Interactive comment on “Hydrological trade-offs due to different land covers and land uses in the Brazilian Cerrado” by Jamil A. A. Anache et al.

We would like to thank the anonymous **referee 2** for the kind words in support of our manuscript and for the time spent reviewing our text. Here, we replied the referee's comments, which were highly insightful and enabled us to improve the quality of our manuscript. Note that the original referee's comments are identified as R2Cxx and written in **bold**, and the authors' responses are labeled as AR-R2Cxx. In addition, all comments are numbered (xx).

Fig. 1. Figure 2 (see caption above)

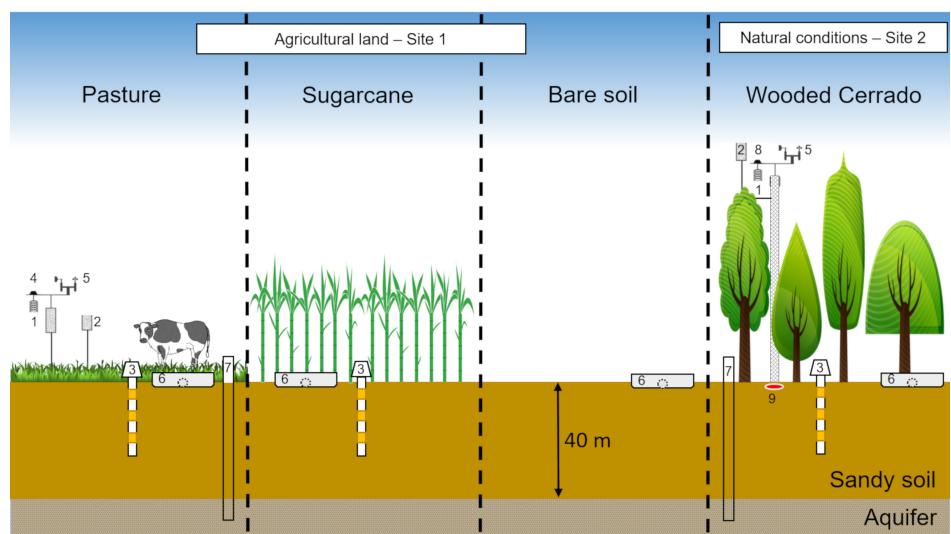
R2C2: In sub-Section 2.2 (“Experimental setting and instrumentation”), please clearly describe the monitoring infrastructure (refer to Fig. 2) by adding information on soil moisture probes, monitoring wells which are described in other parts of the manuscript. Please add the thickness of the unsaturated zone (40 m) in Fig. 2.

AR-R2C2: Thank you for the suggestion. We added the thickness of the unsaturated zone in Fig. 2 (see Fig. 2) and additional information will be added in section 2.2 to better describe the monitoring wells and soil moisture probes.
